Access Compliance Report Public Rights-of-Way (Pedestrian Signals)

Main Street: **NEWPORT_AVE** Cross Street: **LA_LOMA_DR** Location: **SE**

ADA ID: **SGRK211008141541** Signal Type: **One Push Button-APS** Overall Compliance: **No** Severity Scores: **BTN 1: 25** **BTN 2: N/A** **No BTN: N/A**

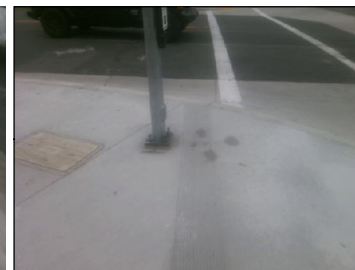
OC Std/PROW: **R404.2, R404.3**

Possible Solutions: Remove and Replace Clear Space.
